UNITED STATES PATENT AND TRADEMARK OFFICE

Office Action Summary

Application No.
09/531,769

DETAILED ACTION

Not Approved- Do not enter.
- New Matter - circled in Red

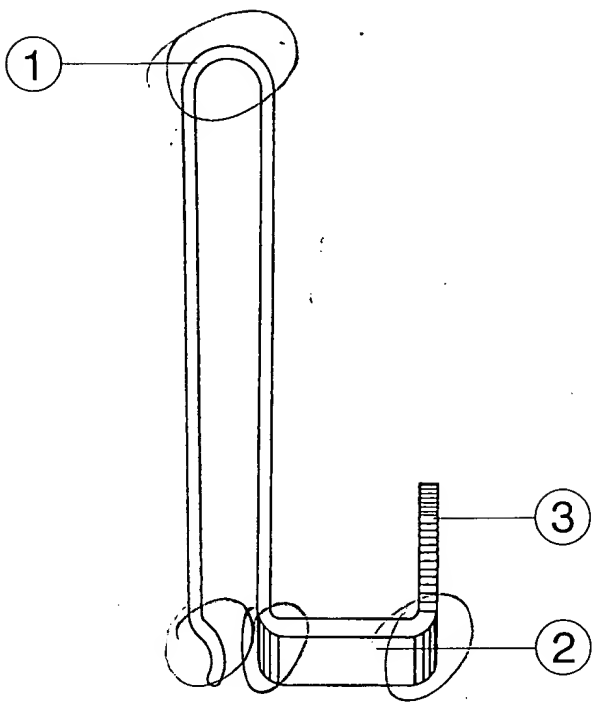
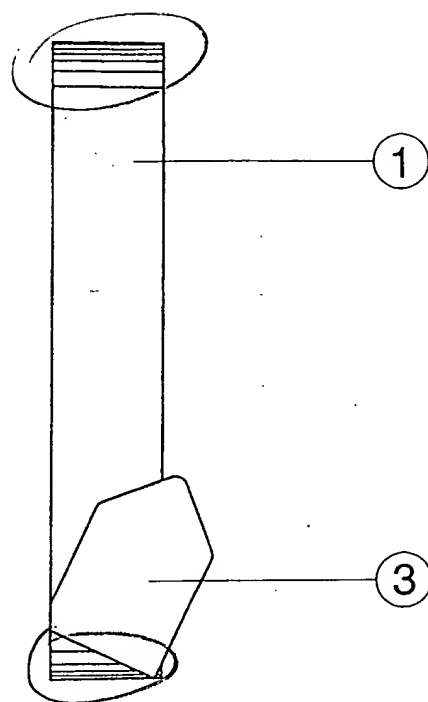
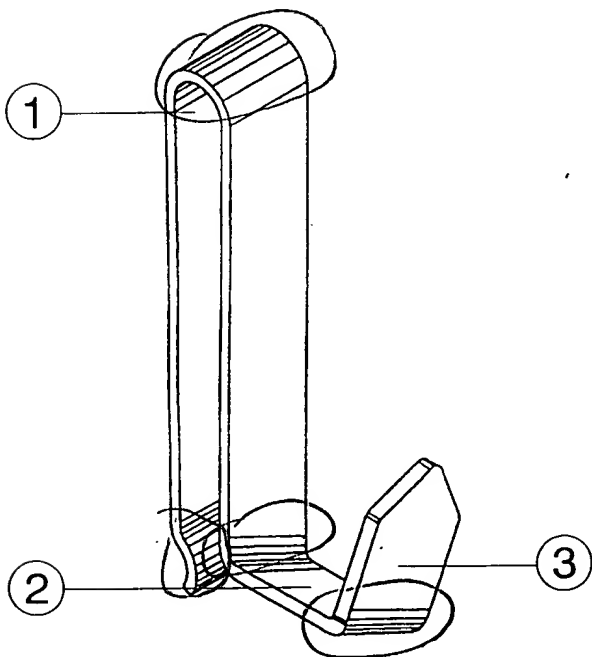
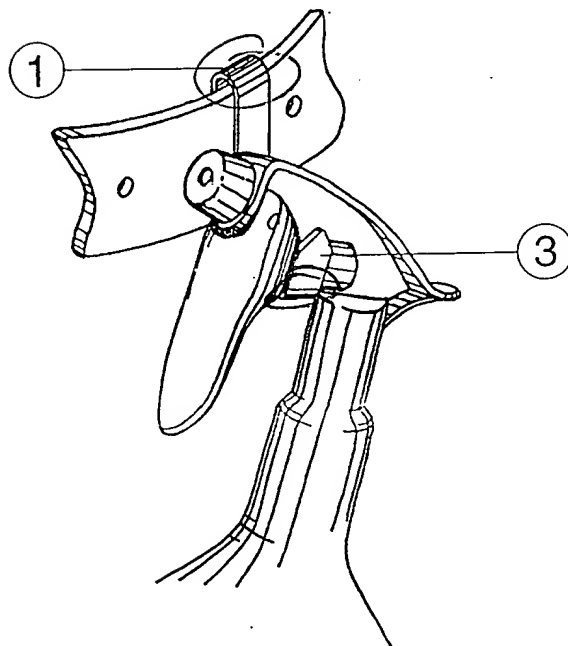
4. The proposed substitute sheets of drawings, filed on 8/20/2001 have been disapproved because they introduce new matter into the drawings. 37 CFR 1.121(a)(6) states that no amendment may introduce new matter into the disclosure of an application. The original disclosure does not support the showing of the curved/radiused features circled in red in the attached marked-up copy of the proposed drawing sheet (See Appendix). The original disclosure and written specification did not support the belt hook having the curved-radiused (i.e., rounded) portions at the proximal ends of the planar members comprising the hook. The originally filed drawing sheets support a disclosure of the belt hook device having planar members, where each of the body back, body front and rest are rectangular shaped planar members, and the rest guard

being a planar member having a tapered distal end portion, as shown in Fig. 4 of one of the two originally filed drawing sheets. Consequently, the proposed substitute drawing sheet has not been approved for entry.
